AGENDA ITEM 8A  
May 4, 2021  
**Worksession**

Council worksession to discuss the recommendations of the Planning, Housing, and Economic Development (PHED) Committee regarding Planning Board Draft of the Ashton Village Center Sector Plan.

SUBJECT: Ashton Village Center Sector Plan

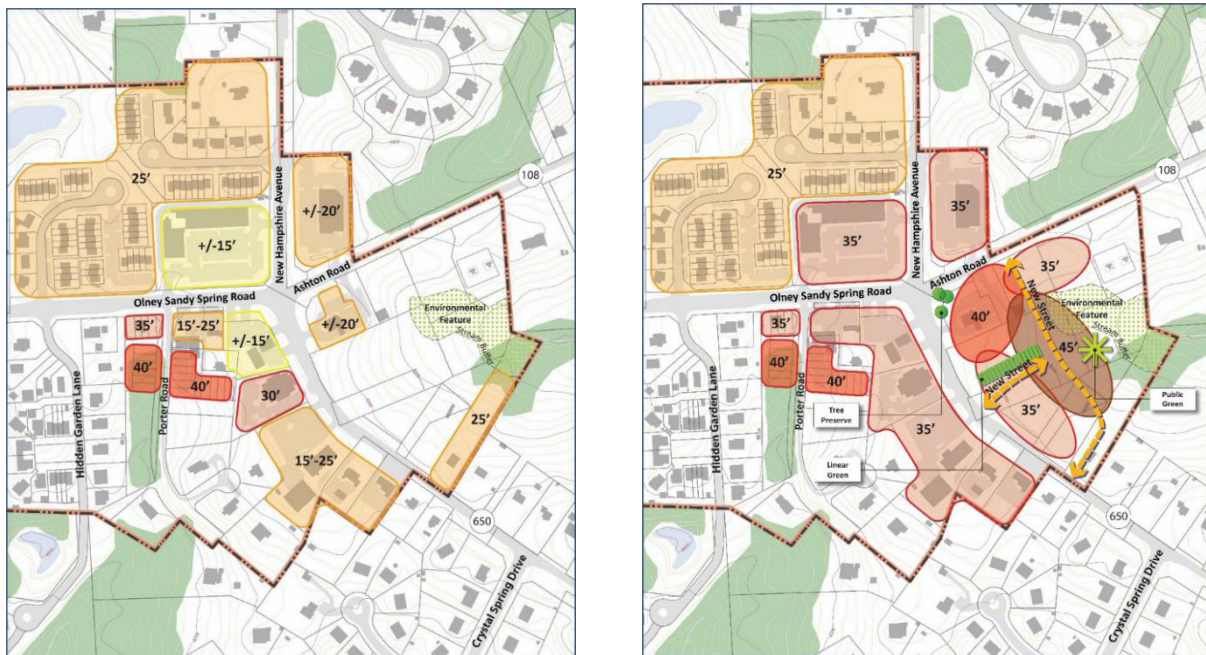
The Council received testimony from Francoise Carrier on behalf of the Nichols Development Company, the master developer of the approximately 9.3 acres of land in the southeast quadrant. Ms. Carrier requests that the recommendation that a majority of buildings should contain pitched roofs be deleted. In addition, she asks that the text for Figure 4 on page 39 clarify that it depicts suggested development patterns for the properties in the southeast quadrant, not maximum building heights. In fact, Figure 4 does note this; however, combining maximum zoning height and suggested maximum height (that does not equal the zoning height) on one map is confusing.

**PHED Committee recommendation (2-0): Councilmembers Riemer and Friedson concur with the Planning Board’s areawide community design recommendations, except for the reference to Figure 4. The Committee recommends that the right side of Figure 4 on page 39 be removed from the Plan and the reference to Figure 4 under the eighth bullet above be deleted.**

**1. Clarify that height bubbles in Figure 4 show suggested development pattern, not maximum building heights.**

Figure 4, reproduced below, includes a series of ovals that could be viewed as imposing rigid height limits in various sectors of the SE Quadrant Property. The Planning Board discussed building height for this site extensively, and nothing in that discussion suggested that building heights should be limited to 35 feet in any given location, or that buildings of similar height should be clustered together in certain areas. On the contrary, the Sector Plan specifically recommends that building heights vary from one building to the next. Moreover, the focus of discussion before the Planning Board was on creating appropriate transitions to surrounding development, with lower building heights at the edges and higher building heights at the corner and in the interior of the site.

Figure 4. Existing building heights (left) and **suggested development patterns** ~~maximum proposed building heights~~ (right) in the Village Core neighborhood and surroundings. **Figure 4 includes,—including** suggested building heights for buildings in the southeast quadrant showing the tallest buildings in the interior of the quadrant and maintaining a transition along the state highways, **but this exhibit is not intended to limit specific building heights in any location except as required in other sections of this Plan.**
